Access Compliance Report

Public Rights-of-Way (Curb Ramps)

Intersection ID: 43498	Main Street: DALTREY_LN	Cross Street: PRESCOTT_HILL_AV	Location: NW
ADA ID: 93F6DC48CD62	Ramp Type: PerpDiag	Initial Pass/Fail: Fail	Overall Compliance: No
Severity Score: 22.5			
Codes/Mitigation Info/Possible Solution		Field Measurements/Component Compliance

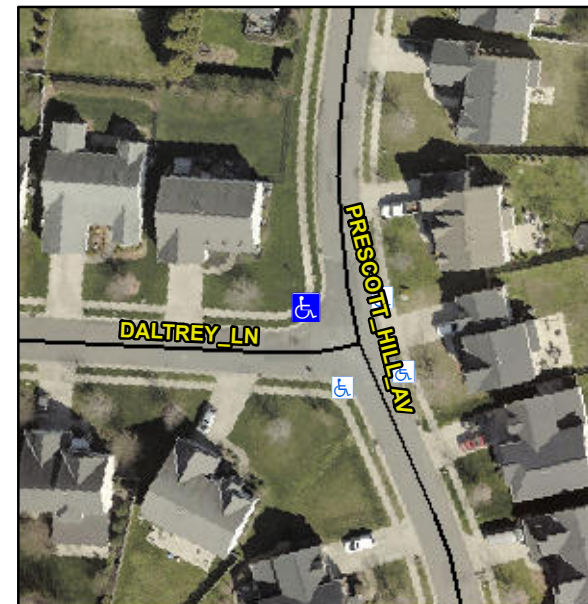
Not Found, R304.5.1, R304.2.2, R304.5.3

Compliance	Description	Data	Compliance	Description	Data
N/A	Ramp Length (in)	48.0	No	Ramp Slope (%)	9.8
No	Ramp Width (in)	42.0	No	Ramp XSlope (%)	4.2
N/A	Flare Type LT	N/A	N/A	Flare Type RT	N/A
N/A	Flare Slope LT (%)	N/A	N/A	Flare Slope RT (%)	N/A
N/A	Flare Traversable LT?	N/A	N/A	Flare Traversable RT?	N/A
N/A	Landing Length (in)	N/A	N/A	DWS Provided?	N/A
N/A	Landing Width (in)	N/A	N/A	DWS Contrast?	N/A
N/A	Landing Slope (%)	N/A	N/A	DWS Length (in)	N/A
N/A	Landing X Slope (%)	N/A	N/A	DWS Full Width?	N/A
N/A	Landing Curb? (Y/N)	N/A	N/A	DWS Offset (in)	N/A
N/A	Shared Landing?	N/A			
N/A	Gutter Ponding?	N/A	N/A	Gutter Slope (%)	N/A
N/A	Gutter Lip Ht (in)	N/A	N/A	Gutter X Slope (%)	N/A
N/A	Painted X Walk1?	No	N/A	Painted X Walk2?	No
	X Walk 1 Direction	To S		X Walk 2 Direction	To E
N/A	X Walk 1 Width (in)	N/A	N/A	X Walk 2 Width (in)	N/A
	X Walk 1 Slope (%)	1.6		X Walk 2 Slope (%)	3.7
	X Walk 1 X Slope (%)	0.9		X Walk 2 X Slope (%)	0.4

Remove & Replace Curb Ramp With Two New Directional Ramps or Equivalent.
